From:
To:
Cc:
Subject: RE: Phase 7 cvc request for initial clarifications [NLP-DMS.FID262297]
Date: 26 October 2018 16:00:14
Attachments:

NYM/2018/0585/CVC – Phase 7 conditions discharge

Request for initial clarifications

Floor Plan
1:100

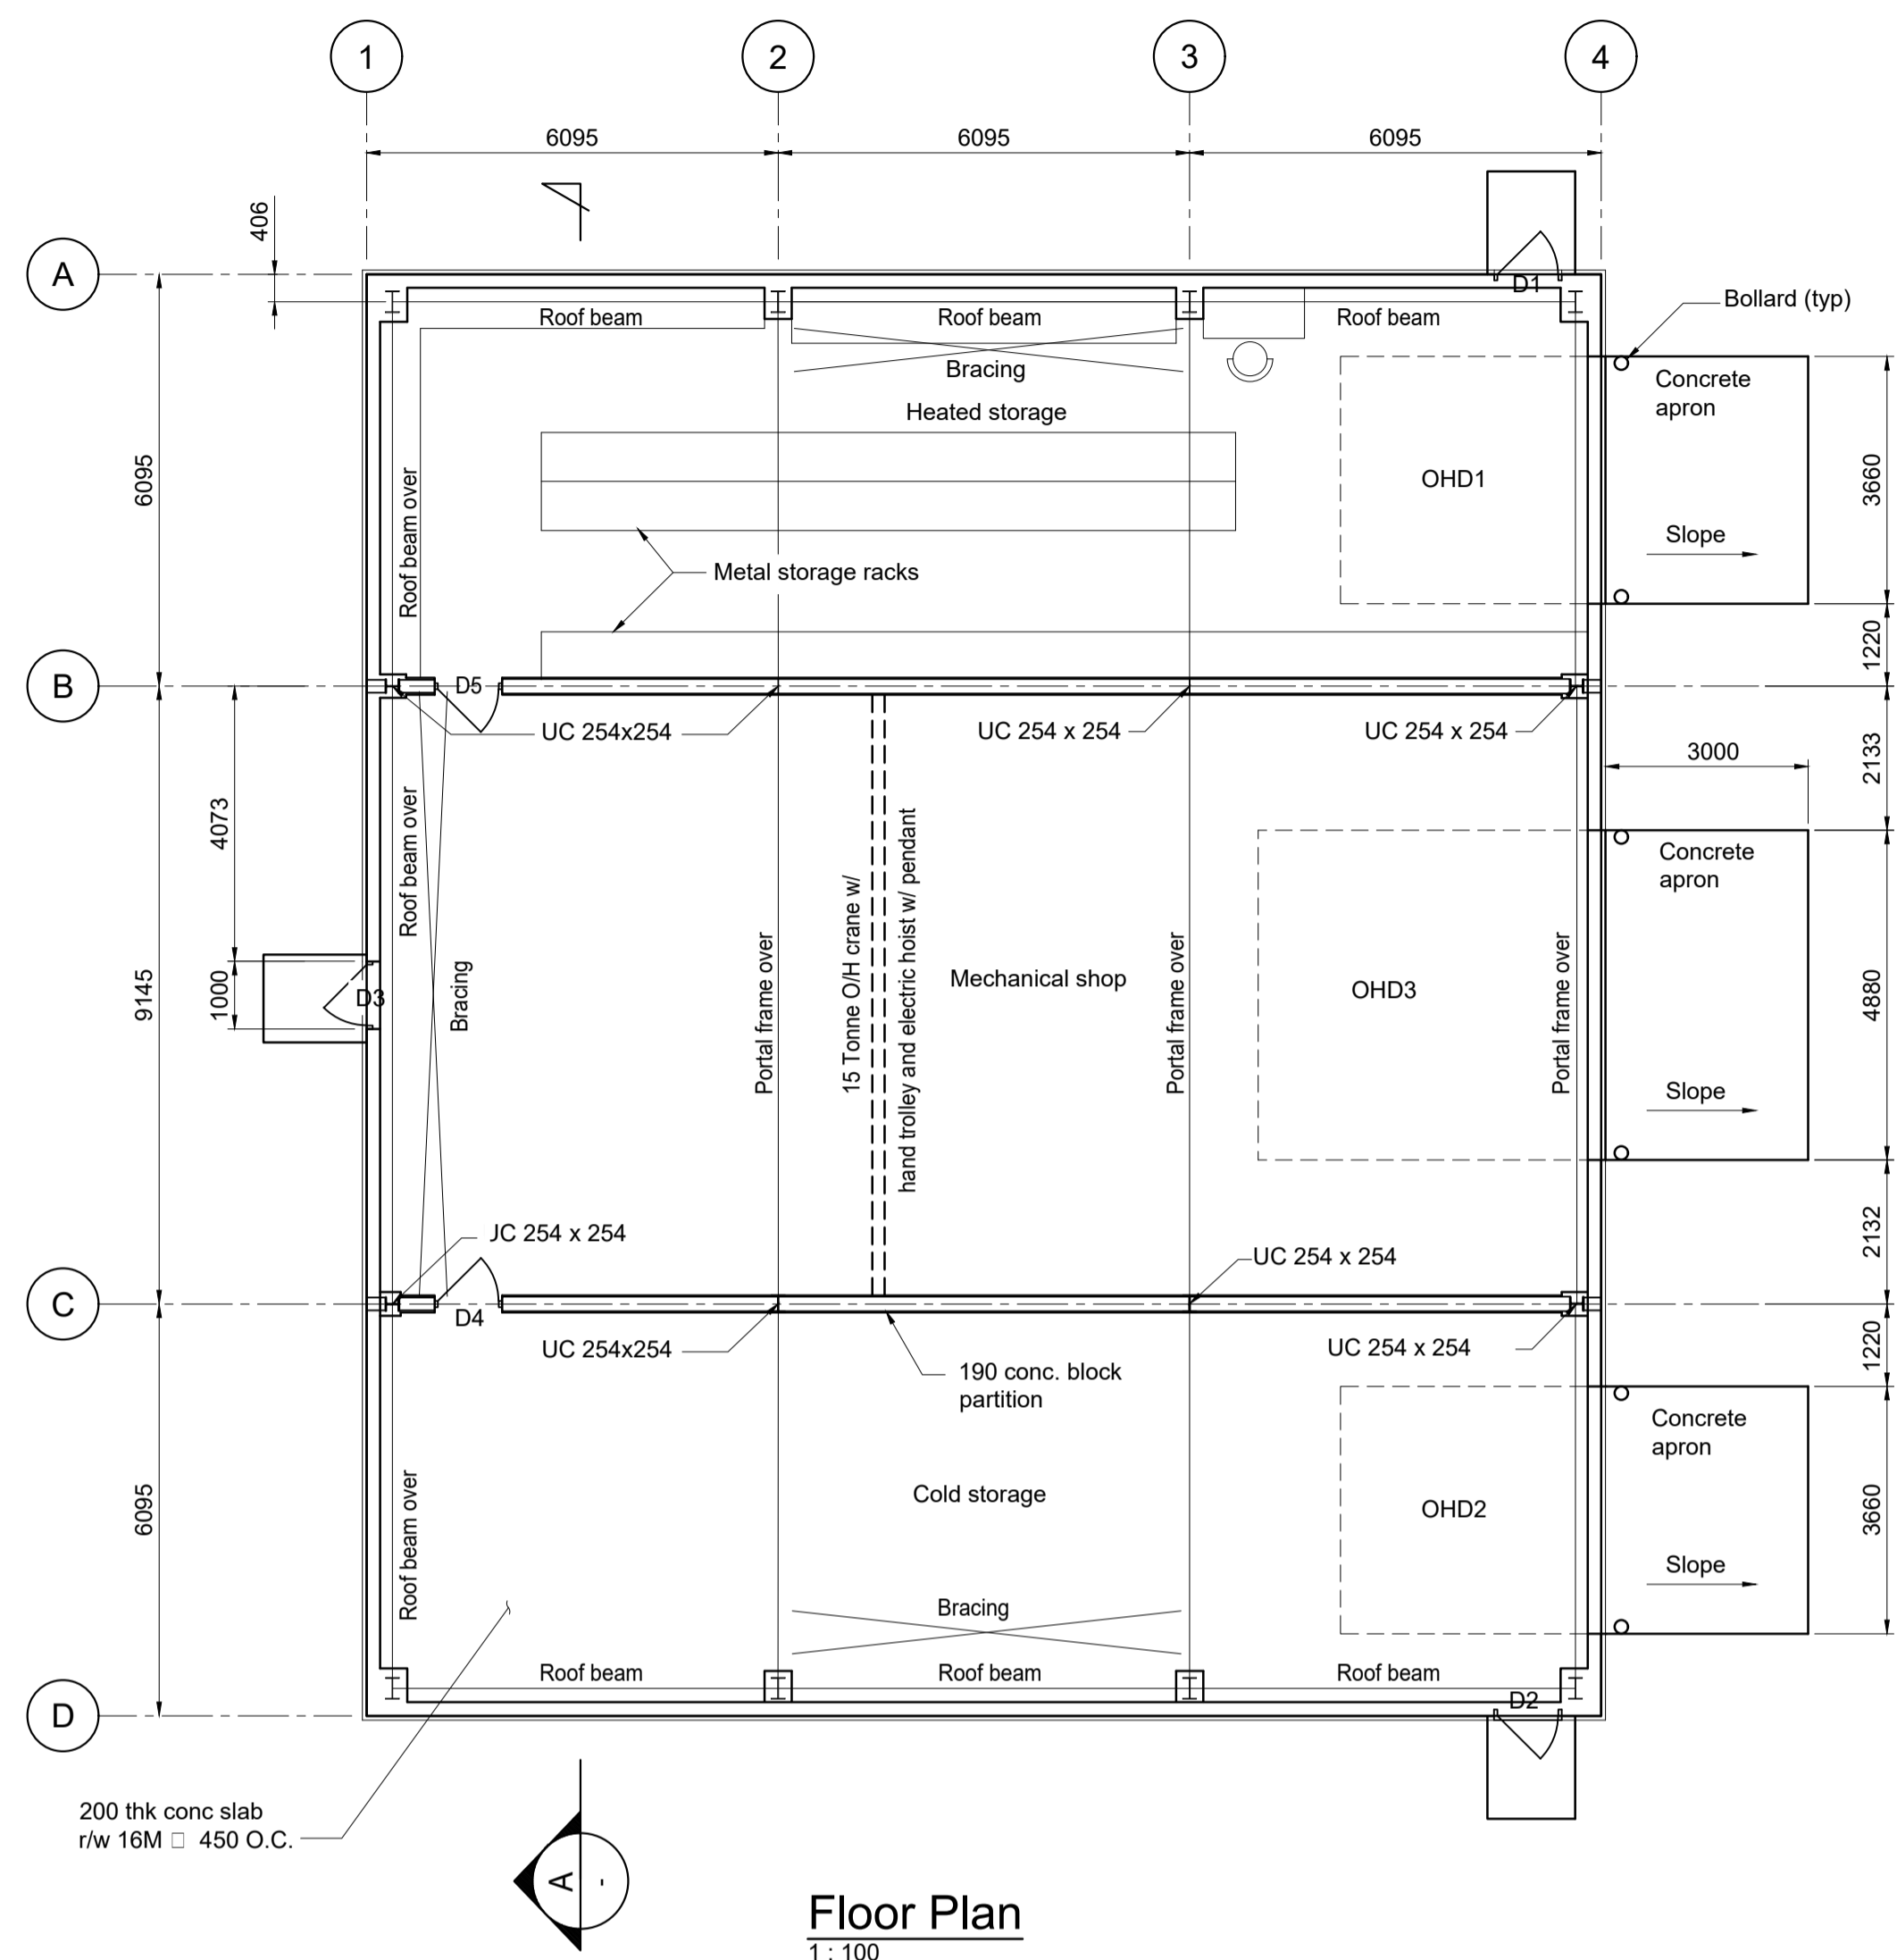
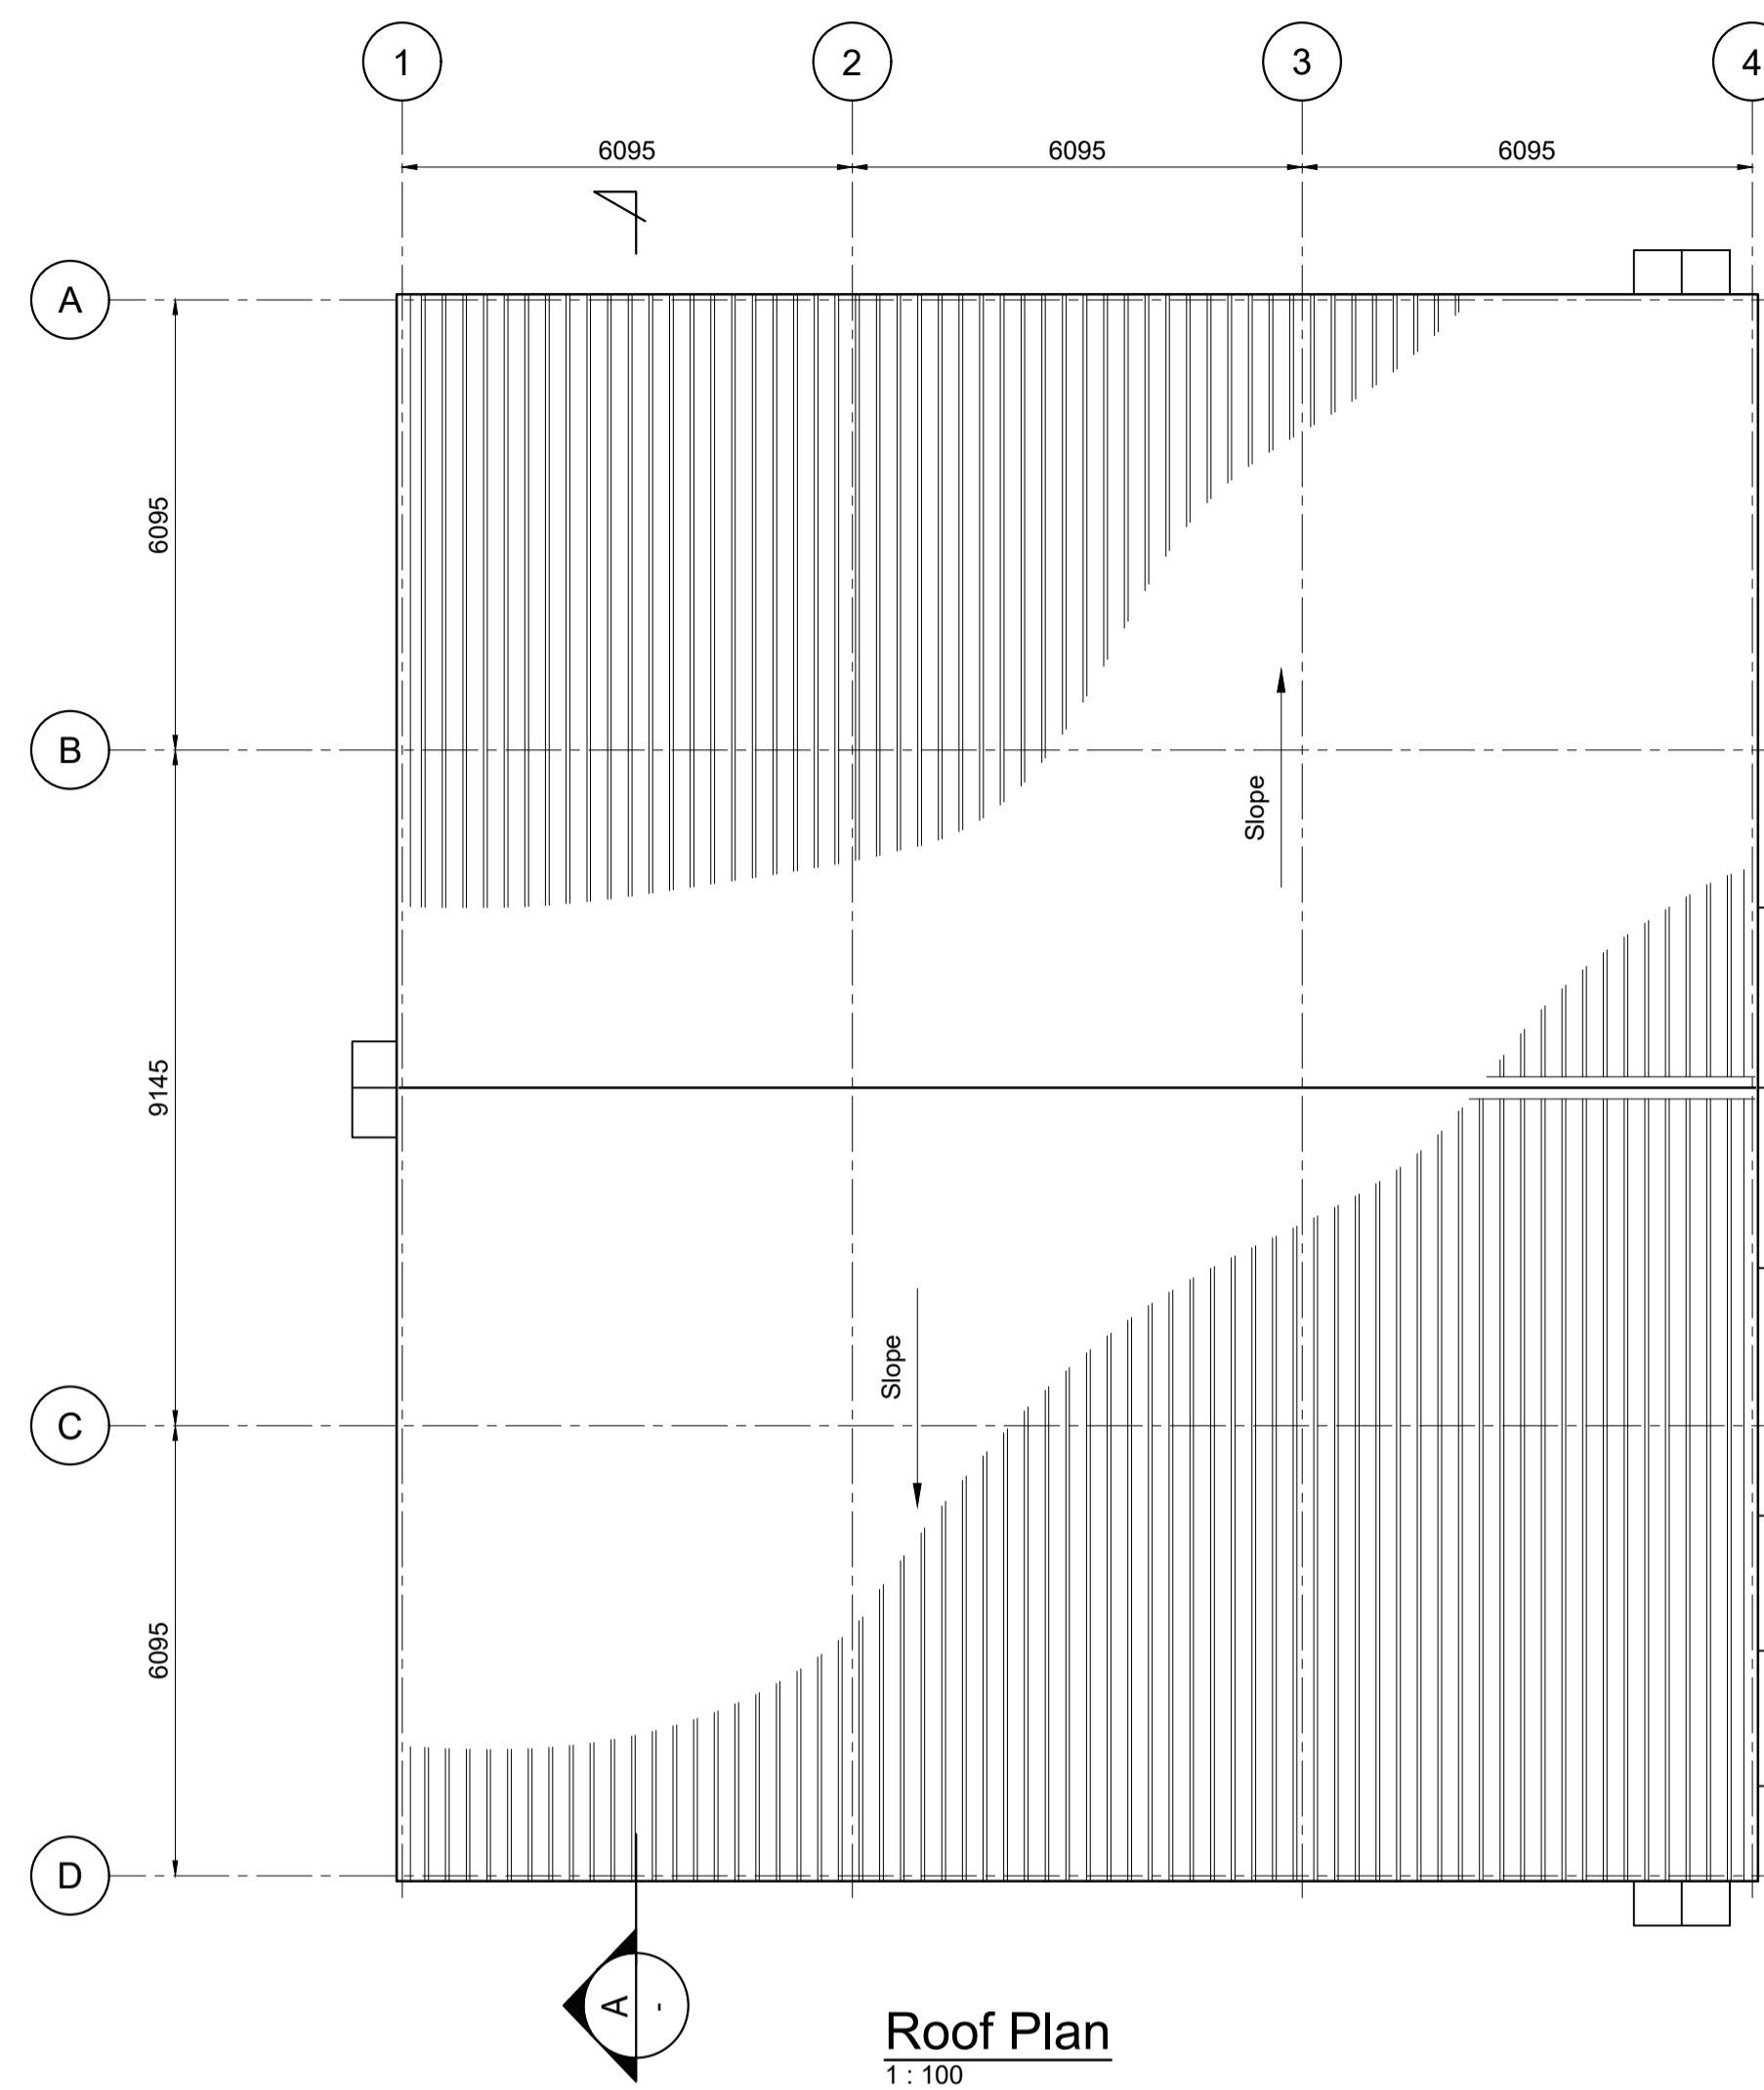
2) Drawing 40-ARI-WS-7100-CI-18-01006 also shows further proposed buildings/structures, including ventilation system structures and temporary workshops/warehouse associated with the service and production shafts. There does not appear to be any information in the submission which indicates the intended size (height) or appearance of these structures. It would be helpful if this could be provided. If it is expected that these structures would be visible to users of the adjacent B1416, it would also be helpful if a representative cross-section to illustrate this could be supplied.

The following scaled drawings are attached in response to q. 2.

Building / Structure	Drawing Numbers
MTS Temporary Workshops / Warehouse	<ul style="list-style-type: none"> • 40-DMC-WS-7219-AR-15-00001 • 40-DMC-WS-7219-GN-18-00001
MTS Ventilation Details	<ul style="list-style-type: none"> • COL-1-0233_MTS Burner Fan 2GAL12-550-550_Rev_C • COL-1-0235_Exhaust Fan_AL14-900_Rev_b
Production Shaft Temporary Winch House	See Construction Method Statement – 3.6.4
Service Shaft Winch House	
Production Shaft and Service Shaft Ventilation Details	These will be the same as those listed under the 'MTS Ventilation Details' above. They will be located within the ventilation system footprints for the Production and Service Shafts, as shown on the submitted Construction Masterplan drawing (ref. 40-ARI-WS-7100-CI-18-01005)
